To: Planning Committee **Date:** March 11, 2008
From: Brian J. Jackson **File:** RZ 07-369284
Director of Development
Re: **Application by Raman Kooner for Rezoning at 11311 Williams Road from Single-Family Housing District, Subdivision Area E (R1/E) to Single-Family Housing District (R1-0.6)**

Project: **Proposed 2 lot subdivision – 11311 Williams Road Richmond
RZ 07-369284**

Re: **Tree Retention Assessment**

BRITISH COLUMBIA LAND SURVEYOR'S CERTIFICATE SHOWING EXISTING TREES ON LOT 3 BLOCK 2 SECTION 25 B4N R6W NEW WESTMINSTER DISTRICT PLAN 18935.

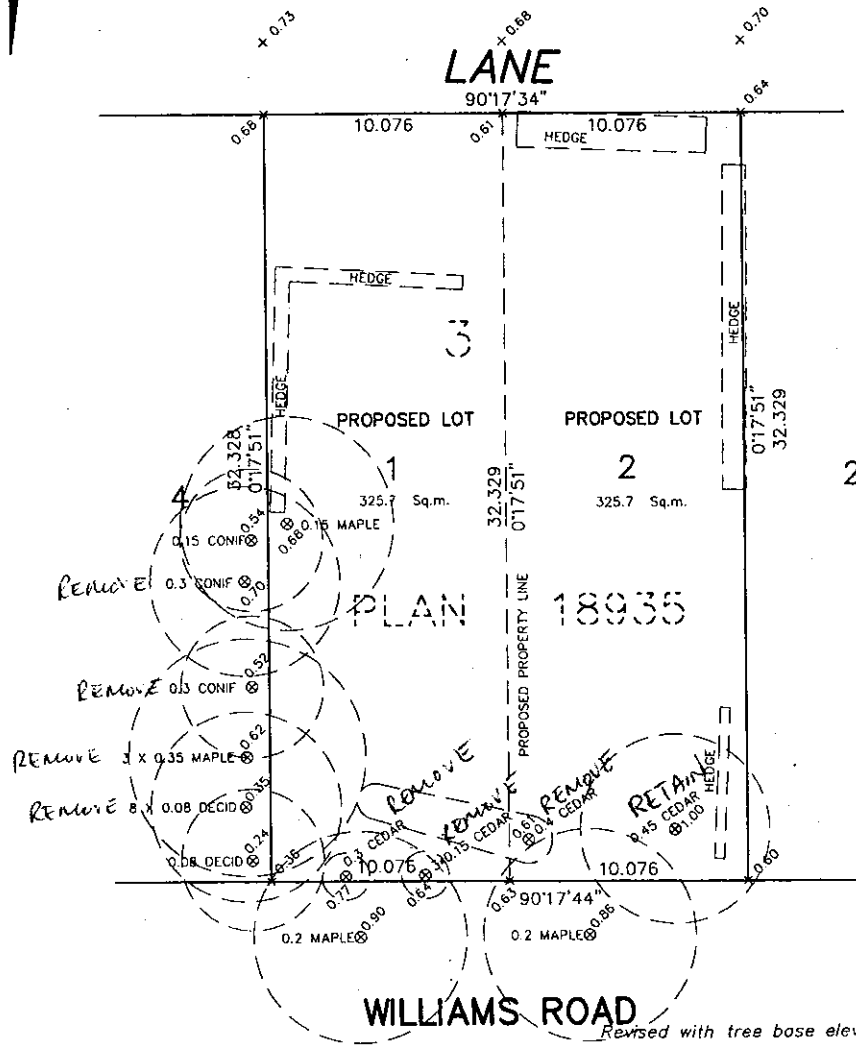
A Tree Survey (**Attachment 3**) submitted by the applicant indicates the location of 13 trees:

- four (4) bylaw-sized trees and one (1) undersized tree on the subject property;
- four (4) bylaw-sized trees and two (2) undersized trees on the adjacent property to the west (11291 Williams Road); and
- two (2) bylaw-sized street trees on City property fronting Williams Road.

A Certified Arborist's report has been submitted by the applicant in support of the application. The report recommends removal of three (3) bylaw-sized trees on-site and retention of the Sequoia tree at the southeast corner of the site. The City's Tree Preservation Coordinator has reviewed and concurred with the Arborist's recommendations for tree removal on the basis of tree condition and conflict with proposed development plans. Based on the 2:1 tree replacement ratio goal stated in the Official Community Plan (OCP), and the size requirements for replacement trees in the Tree Protection Bylaw No. 8057, six (6) replacement trees with the following minimum calliper sizes are required:

Staff also agree that the Sequoia tree should be retained. However, the future dwelling on the eastern lot must be setback 8 m from the front property line to provide additional space for tree and root growth unless the mitigation measures proposed by the Arborist as listed in the Arborist Report Addendum dated Jan 31, 2008 (**Attachment 4**) be implemented. In addition, staff recommend that the Sequoia tree be pruned by a professional arborist for clearance issues and that use of sand-based pavers instead of concrete for any walkways or paths within the front yard of the eastern lot. Installation of retaining walls and perimeter drainage should be hand-dug or installed outside of the tree protection zone. The drainage connection to the eastern lot should be relocated to the western edge of the eastern lot.

The Arborist Report also recommends removal of four (4) bylaw-sized trees located on the adjacent property to the west (11291 Williams Road) – two Maple trees are in poor health, one Hemlock tree is dead, and one Spruce tree is conflict with the proposed development. Although the Spruce tree is in “fair” condition, retention of this tree means a minimum 3.0 m (9.8 ft.) setback from the side property line and a limitation to the wide of a large portion of the future dwelling to 5.8 m (19.0 ft.). Considering this impact to the development potential of the future lot and the applicant’s efforts to protect the Sequoia tree in the front yard, staff support the removal of the Spruce tree.

As a condition of rezoning, a Restrictive Covenant for Tree Protection must be registered on title in order to preserve the Sequoia tree. The Restrictive Covenant will include language to ensure all structures on the future eastern lot are setback 8.0 m from the front property line. The Restrictive Covenant will also include language to allow the front yard setback, including all projections, be reduced to 6.0 m provided that the mitigation measures to prevent root growth beneath the future structures as listed in the Arborist Report Addendum dated Jan 31, 2008 (**Attachment 4**) are implemented. The applicant will provide a security of \$2,000 for tree survival to be held by the City until one (1) year after the Final Building Permit Inspection is undertaken.

The applicant must also submit a proof of contract with Certified Arborist for supervision of on-site works conducted on the subject property within and adjacent to the tree protection zone as identified in the Arborist Report. Tree protection barriers around the Sequoia tree must be installed on-site prior to final adoption or prior to demolition of the existing dwelling on the subject property (whichever occurs first), and remain on-site until the construction of the future dwellings is completed.

A consent letter from the property owner of 11291 Williams Road is on file. A separate Tree Cutting Permit and 2:1 replacement are required for the removal of these trees prior to final adoption of the rezoning bylaw.

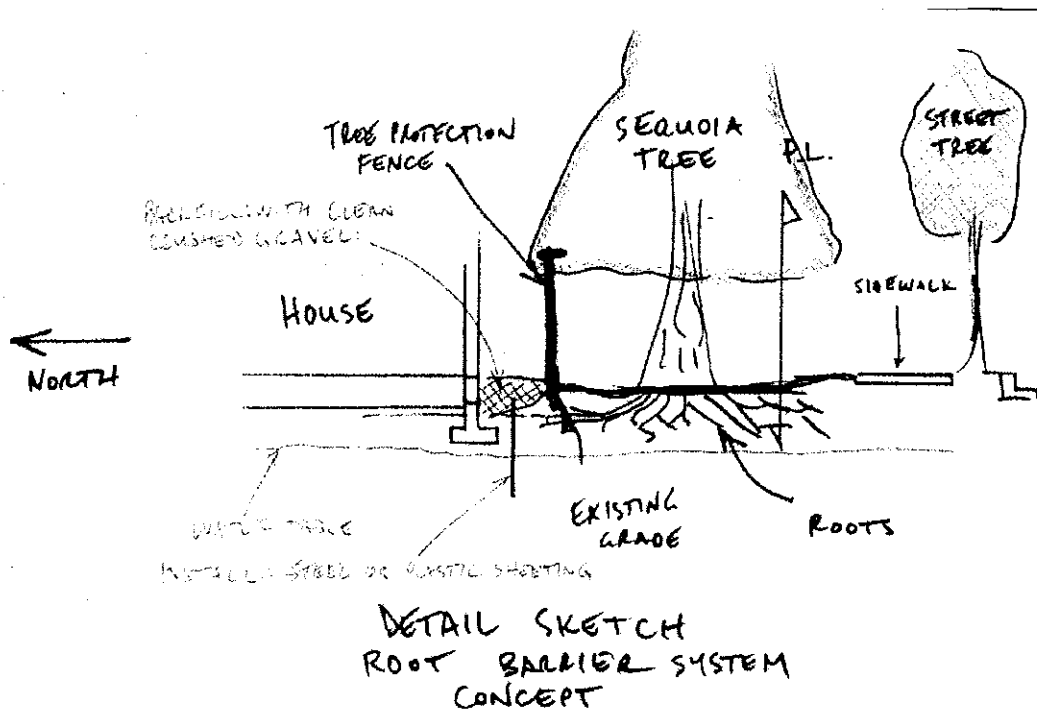
I have received comments from the City review of the Tree Retention Assessment report dated December 19 2007. Further assessment and details are provided below at your request. I reference the points as numbered in the email from Edwin Lee (City) dated January 9 2008. Please forward the revised Tree Retention Plan along with this memo to the City for their records.

1. The two trees must be protected to meet parks department requirements. This is usually a fence to be installed around the sidewalk planter in this type of growing site. Since the site it rear access, it is expected that no building related construction will be undertaken from the front. The service connections may be in conflict with existing trees, however the City crews typically install them to your property line, therefore their own crews should be advised to protect the trees adequately. A note has been added to the plan to address their protection.

2. The protection zone for the Sequoia tree # 536 is a no-access zone as described in the tree protection guidelines on the Tree Retention Plan. Note that a follow-up visit has resulted in a revision to the protection zone to allow sufficient space for underground service connections to be installed on the west side of lot 2 without being in conflict. No retaining walls or perimeter drain can be installed within the tree protection zone.

3. The Sequoia tree dripline is currently 3.5m radius as measured in our field inspection. The tree will eventually grow to have an estimated dripline of 8.0m radius in 30 years. That dripline is shown on the plan for context.

4. The future growth of the Sequoia tree will result in branches growing up to and over a new home constructed to the front yard setback (i.e. 6.0m). This growth can be managed by performing pruning from time to time. The upper foliage that may eventually overhang the house must be left intact, recognizing that additional building maintenance will be required, such as cleaning gutters more regularly than otherwise. All future pruning should be undertaken by a qualified and experienced arborist, certified through the International Society of Arboriculture. The front sidewalk should indeed be constructed using unit pavers instead of concrete so that the future uneven lifting can be easily corrected without hard surface damage and without injuring the roots. The best option would be to provide additional space for tree and root growth on lot 2. For instance, implementing a front yard setback of 8.0m rather than 6.0m will provide relief from encroachments of limbs and roots toward the building. This is not possible without significant detrimental design impacts to the new home.

Root barriers are not always effective, especially in the long term. They may be used at the discretion of the owner. Various products and installation methods are available. This should not be a condition of approval, since there is conflicting research findings in literature as to the usefulness.

For best efficacy to minimize root growth too close to the foundation, I recommend an alternative solution as per the detail below. This method will prevent root growth beneath the barrier by penetrating below the water table, and reduce root growth in the upper stratum by keeping the area inert. The house can be built to otherwise normal standards of construction, to the 6.0m front yard setback without long term impacts.
